UNITED STATES PATENT AND TRADEMARK OFFICE

APPLICATION NO.	FILING DATE	FIRST NAMED INVENTOR	ATTORNEY DOCKET NO.	CONFIRMATION NO.
10/065,495	10/24/2002	Ronald Scott Bunker	839-1333	9074
30024	7590	05/25/2004	EXAMINER	
NIXON & VANDERHYE P.C./G.E. 1100 N. GLEBE RD. SUITE 800 ARLINGTON, VA 22201			RODRIGUEZ, WILLIAM H	
			ART UNIT	PAPER NUMBER
			3746

Office Action Summary

FIG. 3

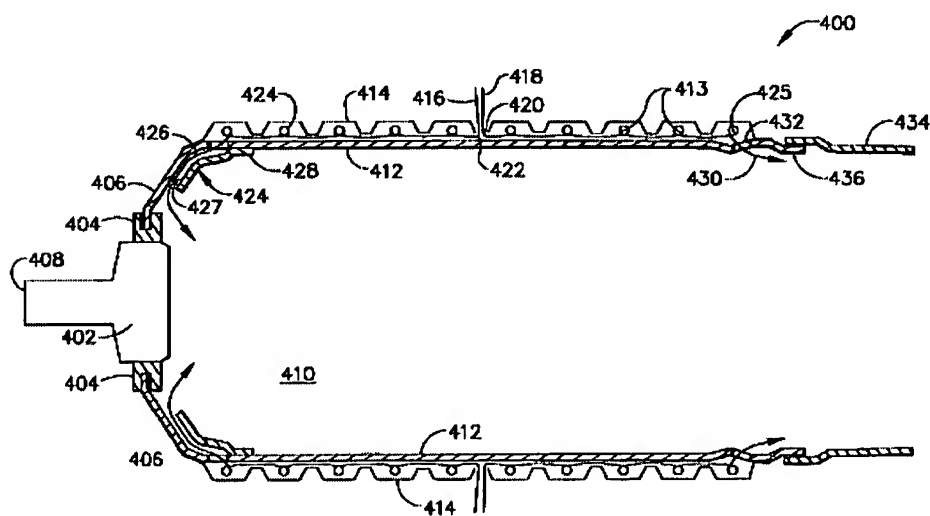
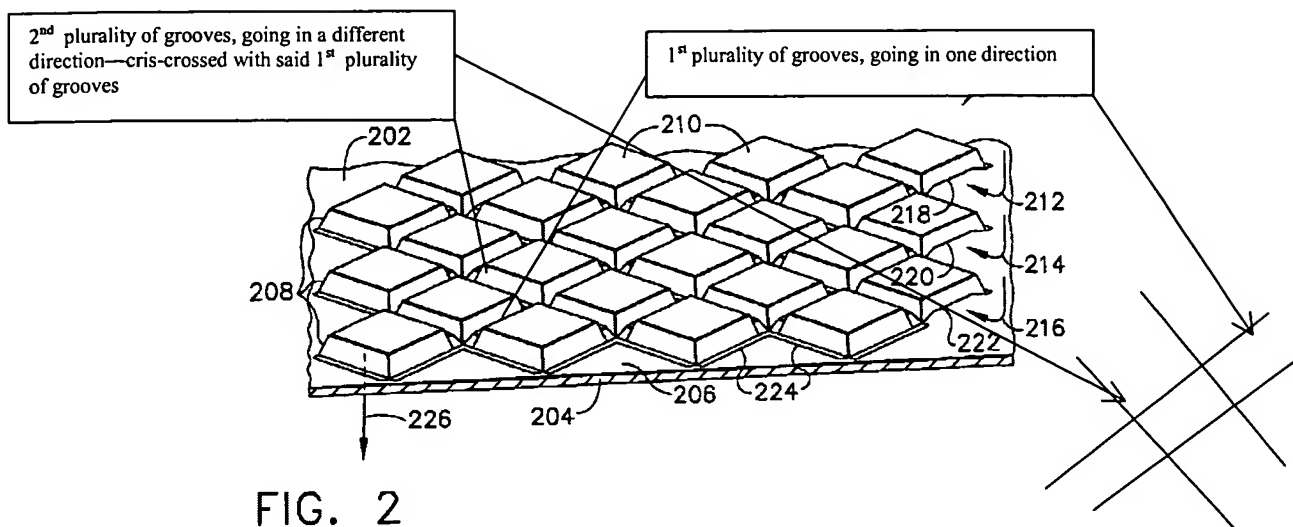
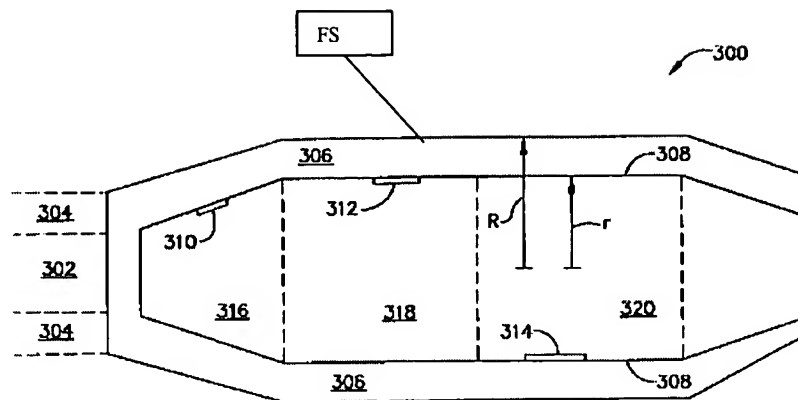
Hadder teaches a combustor comprising a liner for a gas turbine, the combustor liner having a substantially cylindrical shape; a flow sleeve FS surrounding said liner; a first plurality of axially spaced circumferential grooves (space between protrusions) formed in an outside surface of said combustor liner, angled relative to a direction of cooling air flowing between said liner and said flow sleeve; and a second plurality of circumferential grooves criss-crossed with said first plurality of axially spaced circumferential grooves. See particularly **Figures 2, 3, 4**; column 5 line 55 to column 6 line 12 of Hadder.

FIG. 3

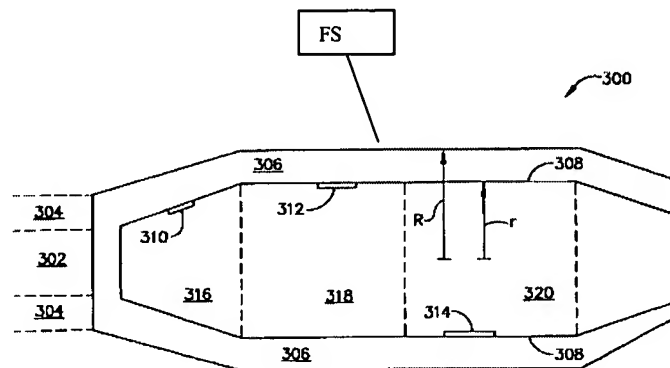
With respect claim 9, page 7 last two lines to page 8 first 3 lines applicant argues that the outer element 414 in *Hadder* is not a combustion liner located concentrically within an outer flow sleeve such that grooves are open to the flow sleeve and air flow flows between the liner and the flow sleeve across the grooves. Examiner disagrees because *Hadder* does teach a combustion liner located concentrically within an outer flow sleeve FL such that grooves are open to the flow sleeve and airflow (304) flows between the liner and the flow sleeve across the grooves. See particularly **Figure 3**, column 5 line 55 to column 6 line 12 of *Hadder*.
